Annual Monitoring Report

Cochran Branch Stream and Wetland Restoration Site

RE: Cochran Branch Stream and Wetland Restoration Site: MY7 Monitoring Report (NCDMS ID 95720)

Listed below are comments provided by DMS on November 22, 2021 regarding the Cochran Branch Stream and Wetland Restoration Site: Year 7 Monitoring Report and RES' responses.

MY7 Stream Reach Substrate Composition

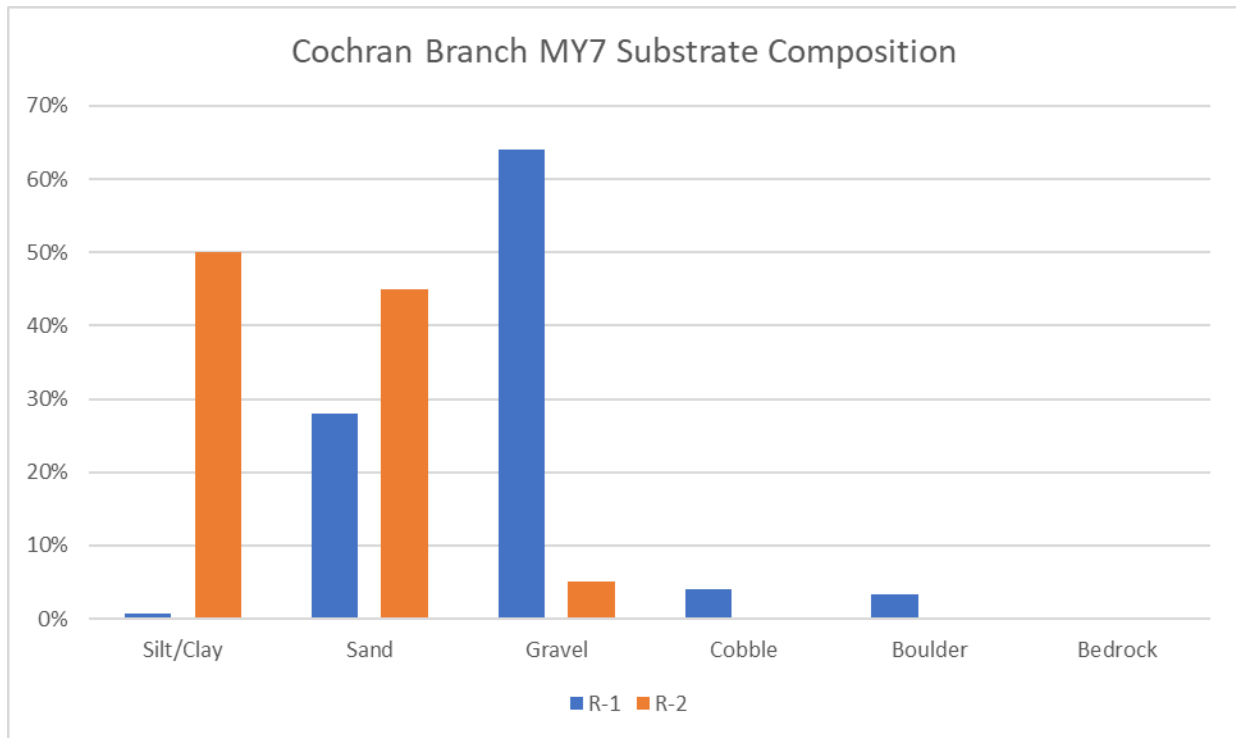
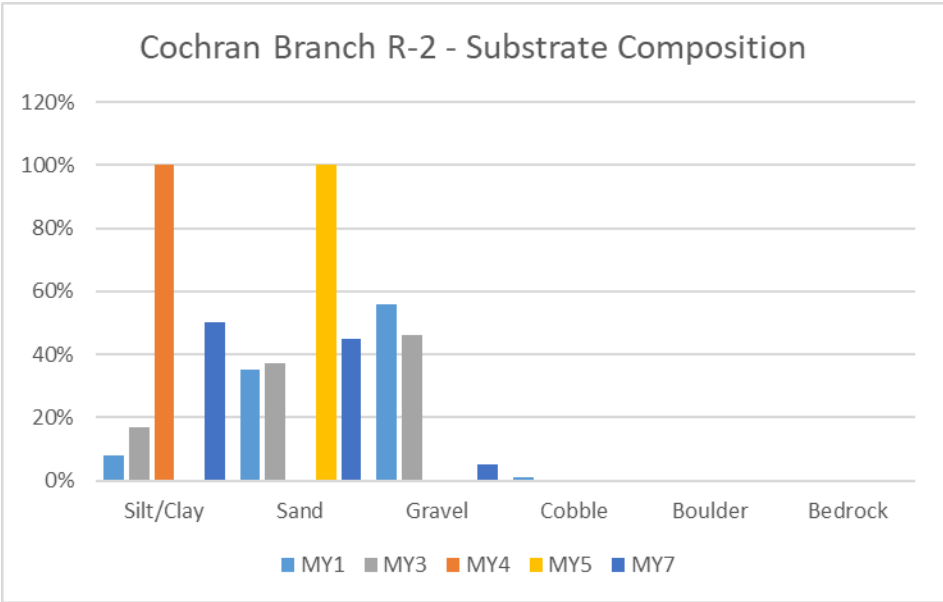
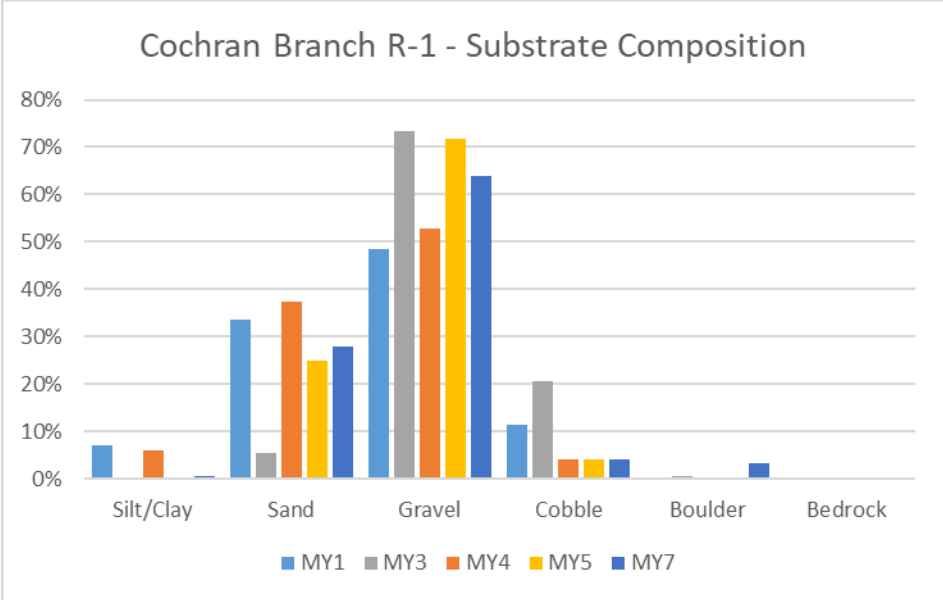
- Please include the data used to create the substrate composition figures.

Done.

MY7 2021 Cochran Branch Stage Recorder

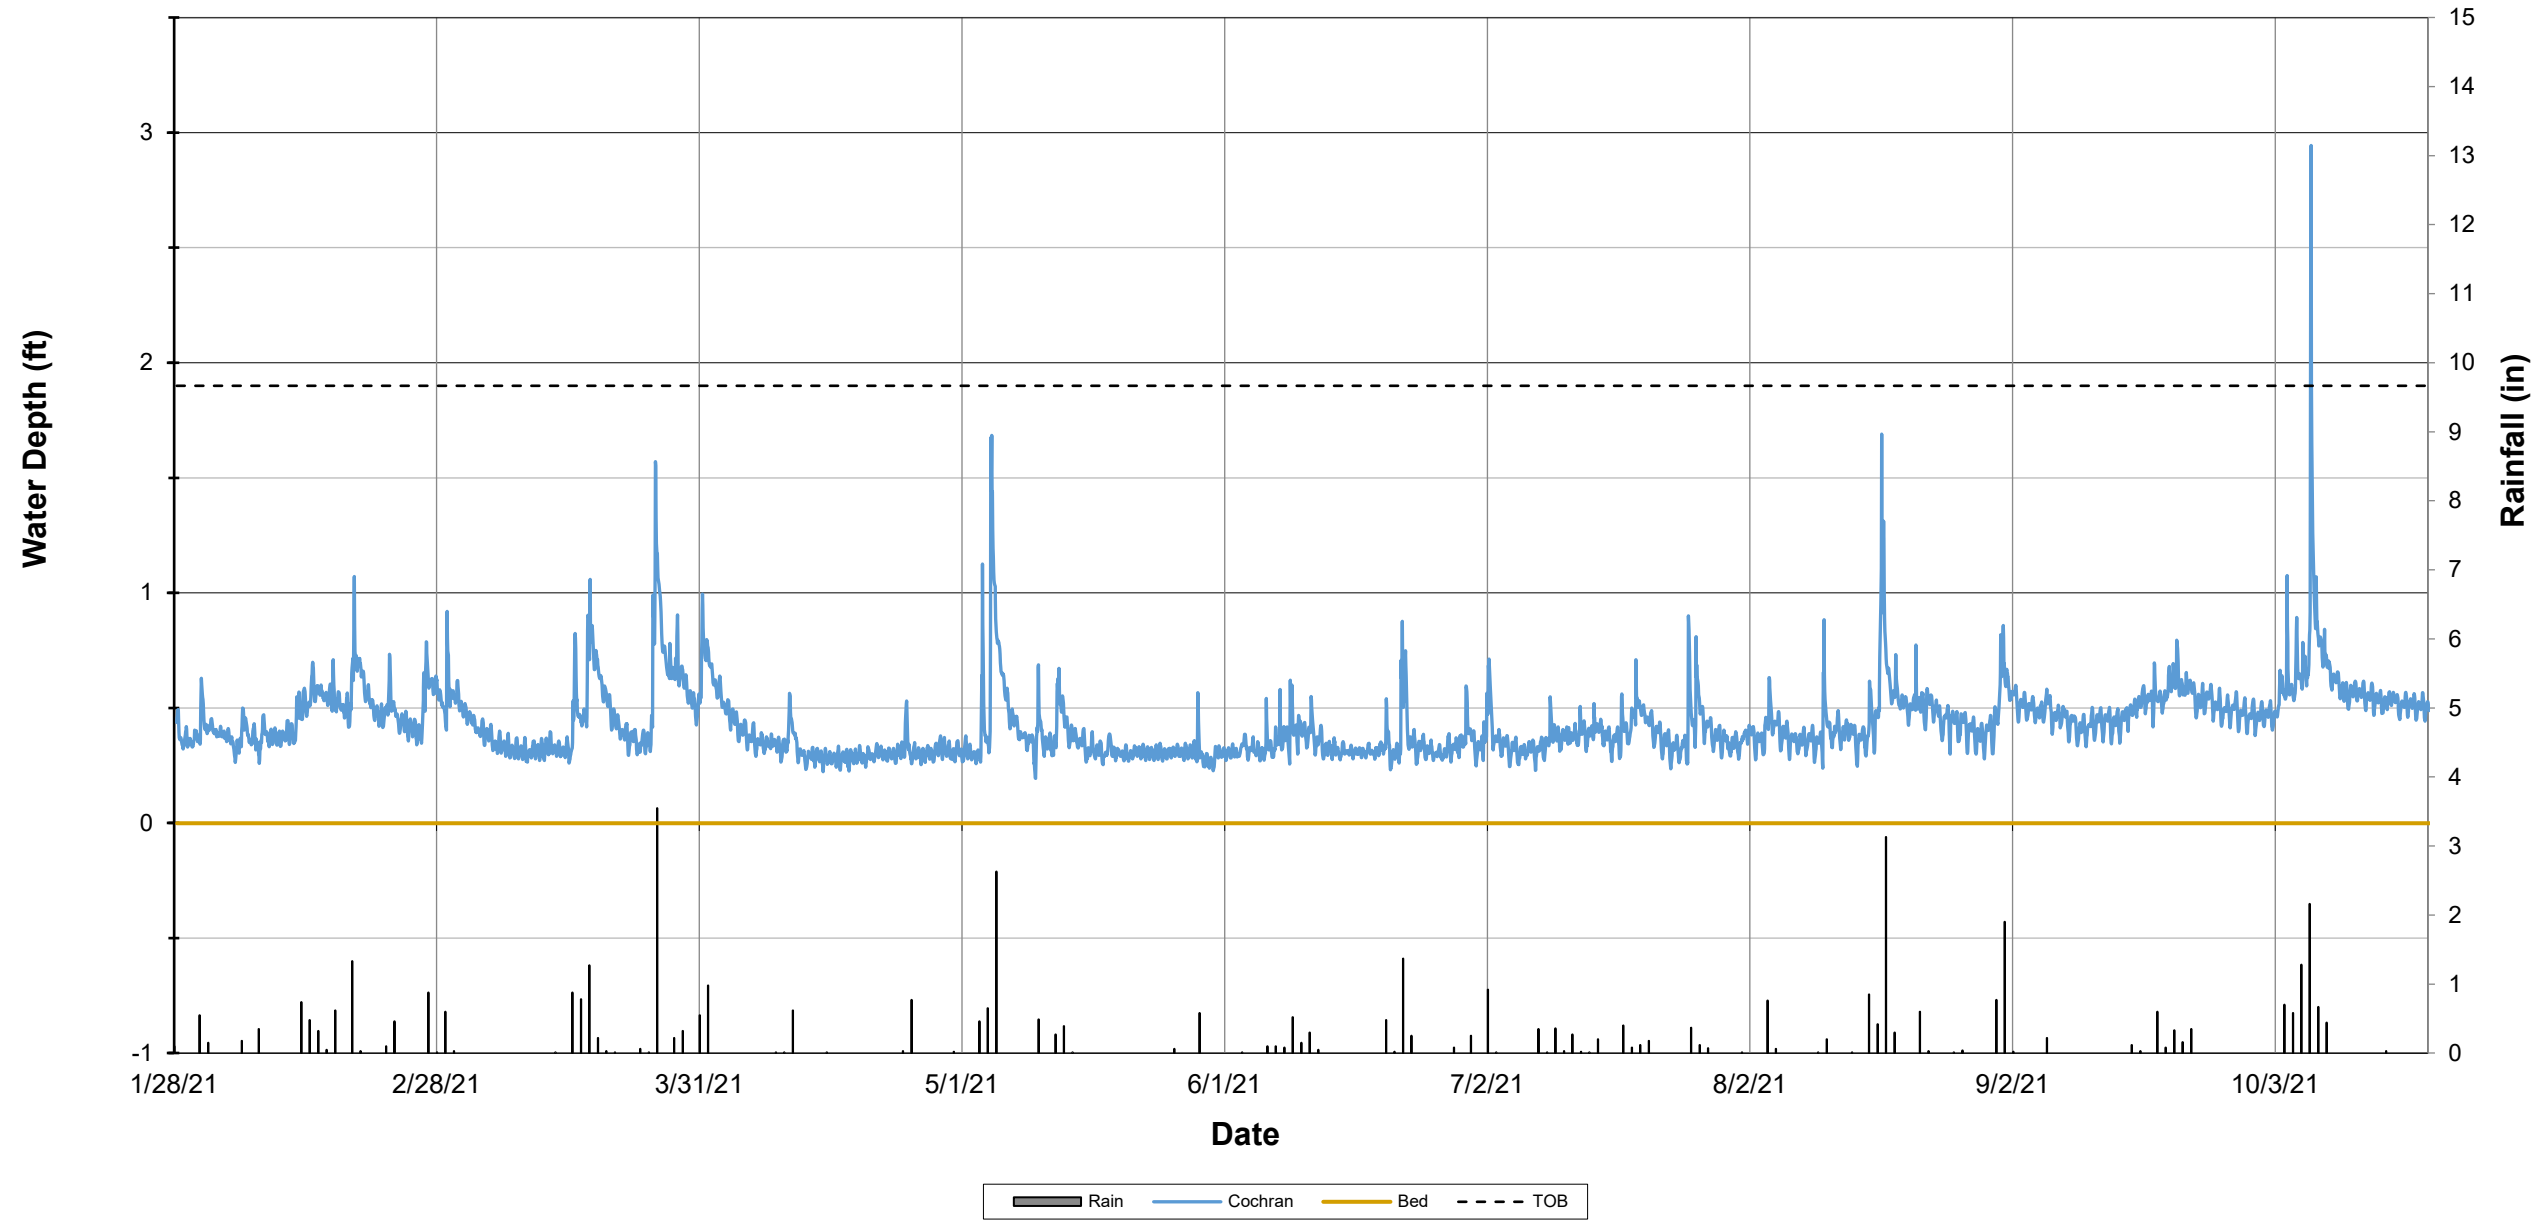
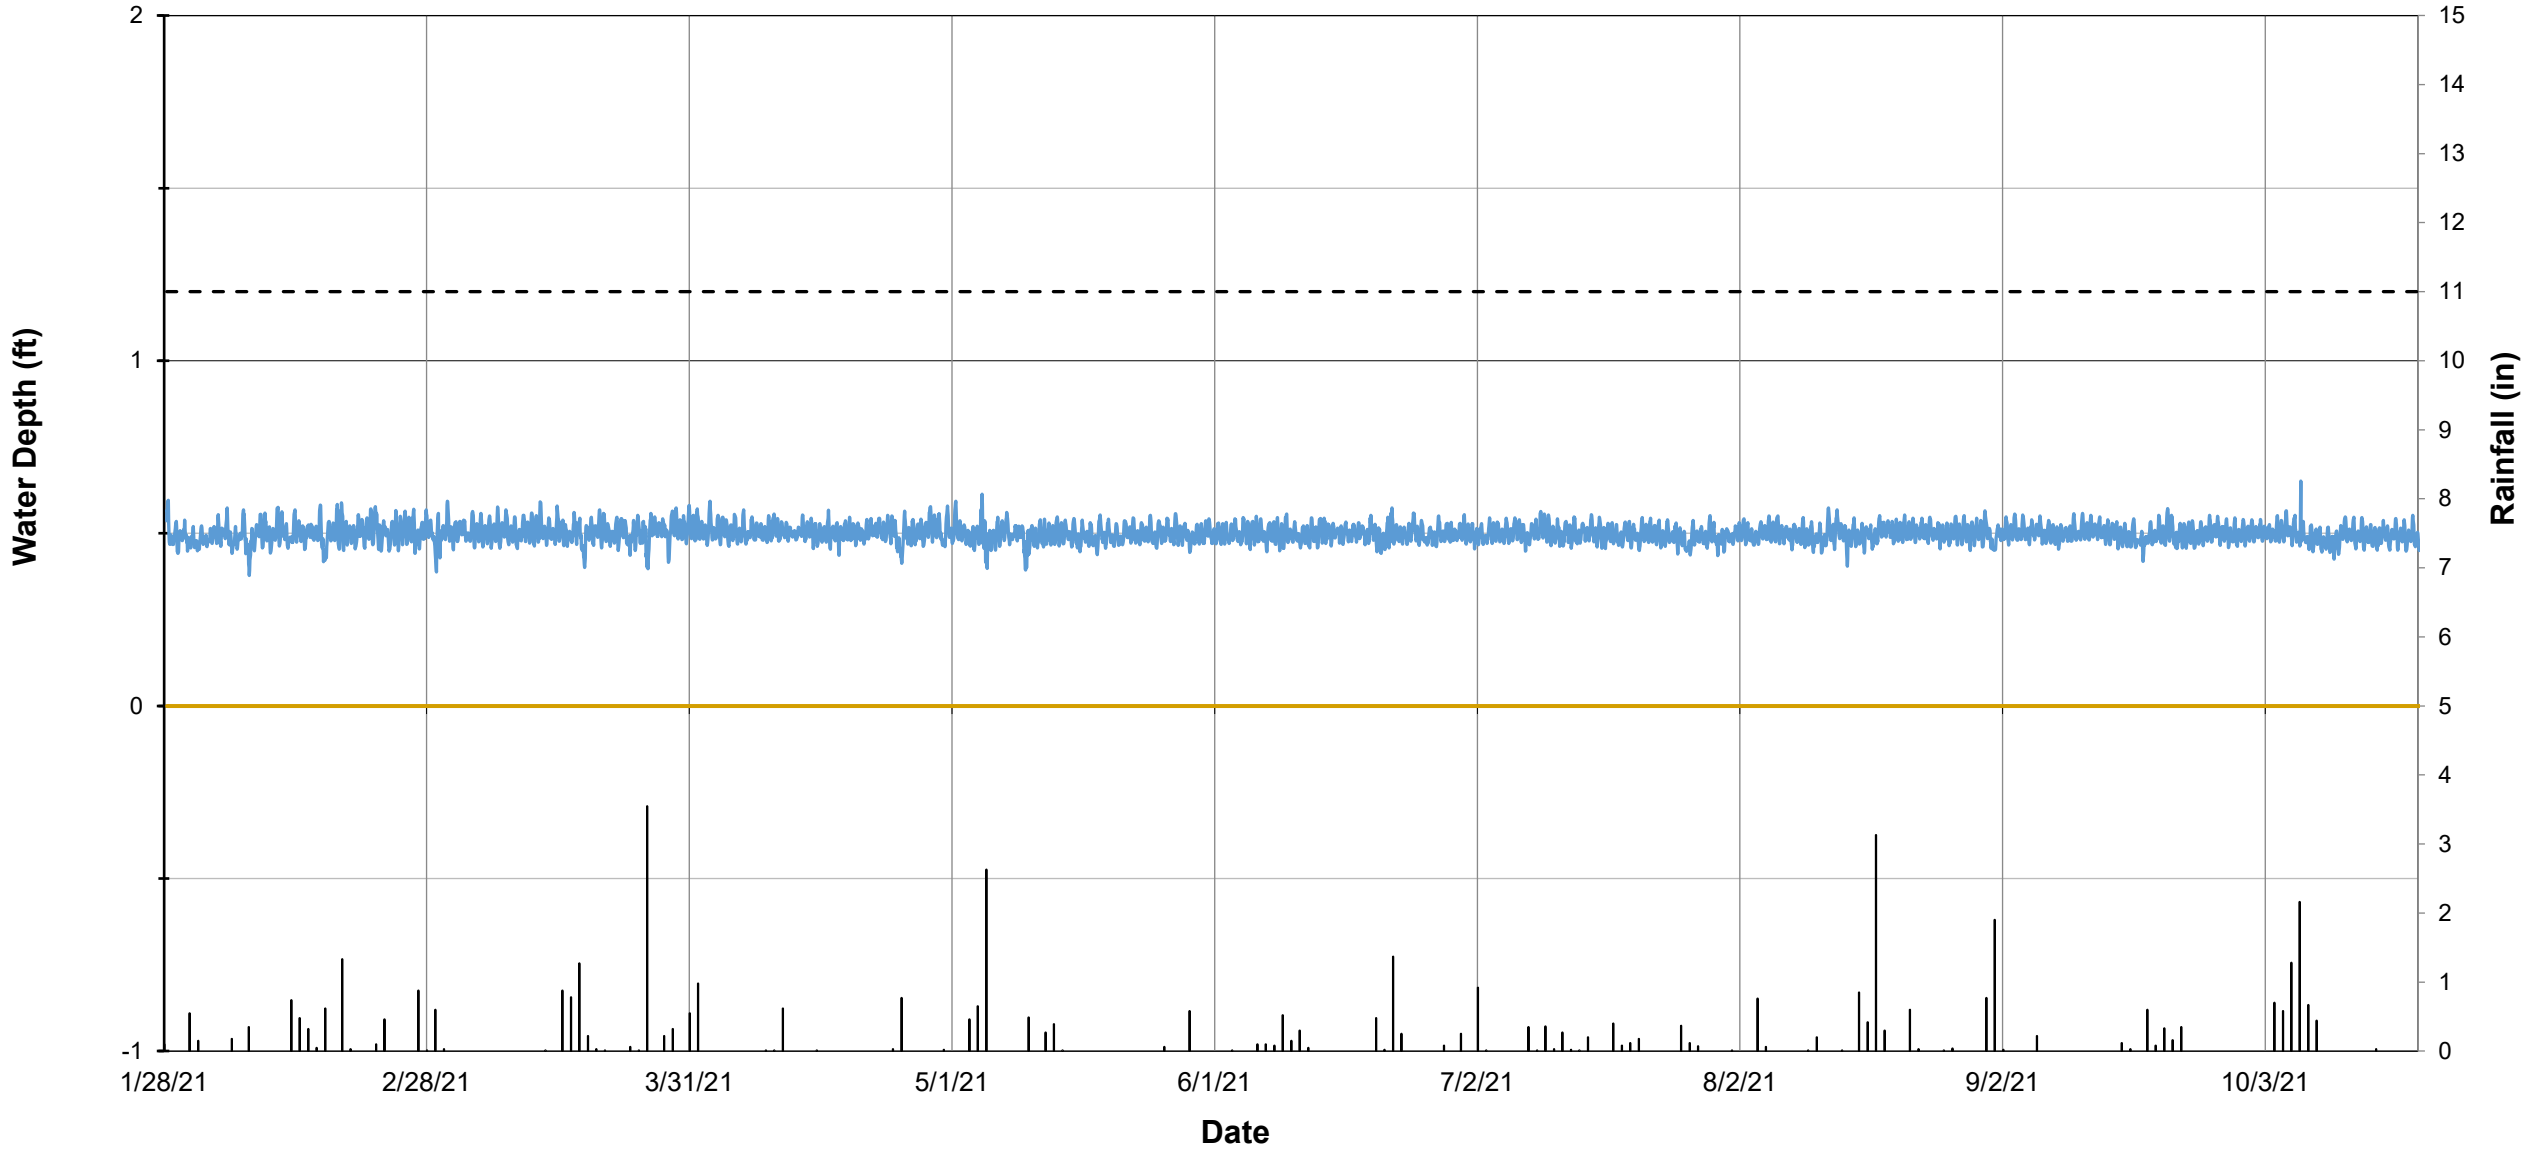
- Please include figures displaying the stage recorder data that was submitted in the CochranB_2021 Well Data workbook.

Done.
